MILITARY SPECIFICATION

CIRCUIT CARD ASSEMBLY 11748240
(SIGHT CURRENT GENERATOR ADAPTER)

This amendment forms a part of Military Specification MIL-C-48585(MU) dated 17 November 1975, and is approved for use by all Departments and Agencies of the Department of Defense.

Figure 1. Test Conditions

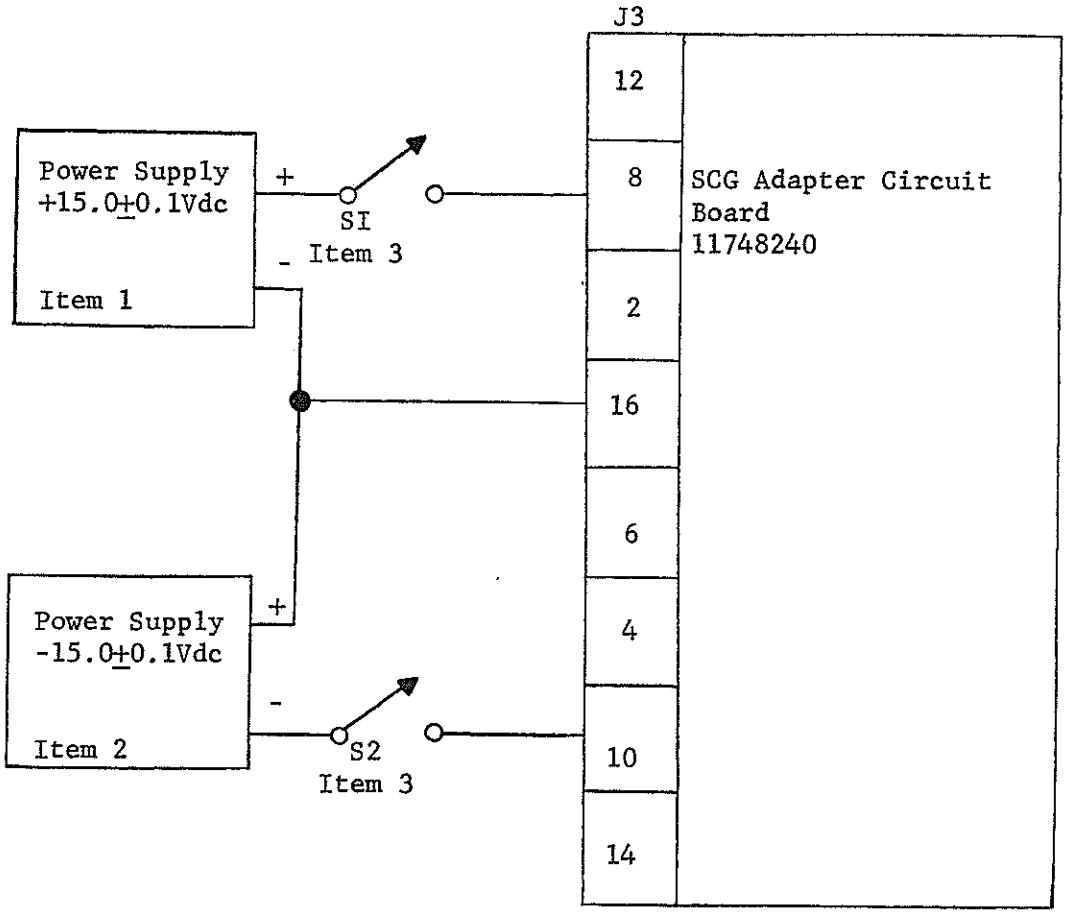
Page 10, Figure 1: Delete and substitute below Figure 1.
